STAFF RECOMMENDATION

305 Broadway

July 15, 2020

Application: New Construction-Violation

Figure 2: ATM at 305 Broadway

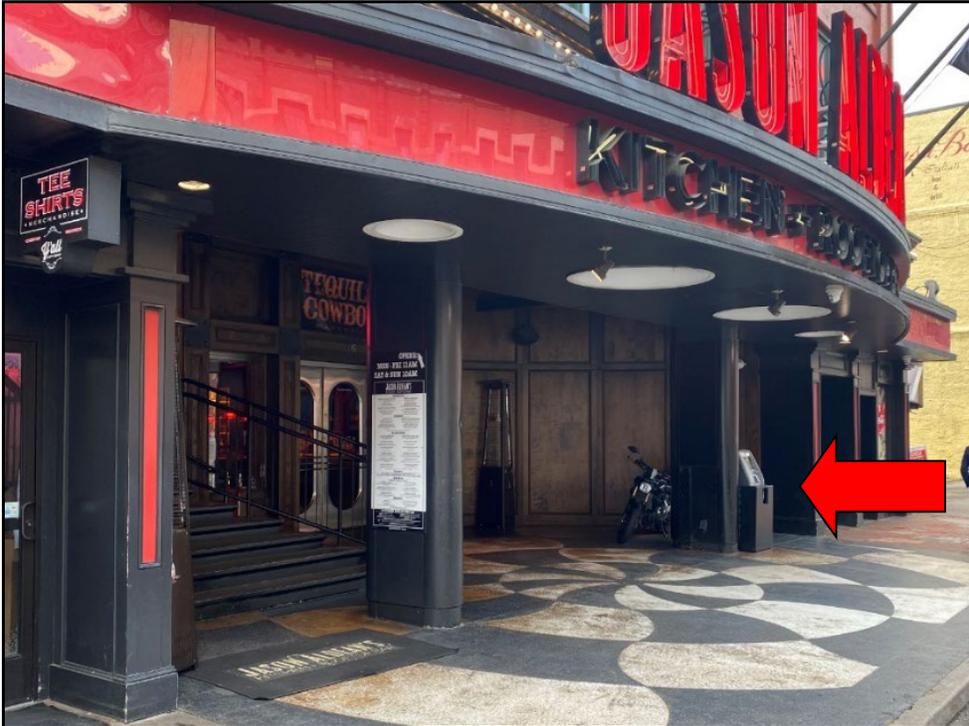
If the revised interpretation of the design guidelines is agreed upon, the current violation would meet the guidelines with the condition that it be relocated to be a minimum of one foot (1') back from the exterior wall line. The ATM is located within a deep recess (approximately eighteen feet deep) on the primary façade but is not stepped back from the exterior wall by at least one foot (1'). It is free standing so does not require the removal of any historic features. It measures approximately four feet, five inches (4'5") high and just over two feet, two inches (2'2") wide, which would meet the three foot (3') wide maximum. The signage is located on the machine itself. No additional lighting or signage has been added or is proposed.

If the Commission finds that the 2004 interpretation is still valid, the ATM does not meet the design guidelines due to its location. The interpretation the Commission established

in 2004 does not allow for ATMs on primary facades. This ATM is located within the recess of the primary façade on the right.

Staff recommends approval if a new ATM interpretation is agreed upon and the ATM is relocated to be one foot (1') back from the line of the exterior wall; finding that the ATM meets the design guidelines for new construction. Staff recommends disapproval if the 2004 ATM interpretation is agreed upon, finding that ATM does not meet design guidelines for new construction. If disapproved, staff recommends that the ATM be removed within 60 days of the date of decision.
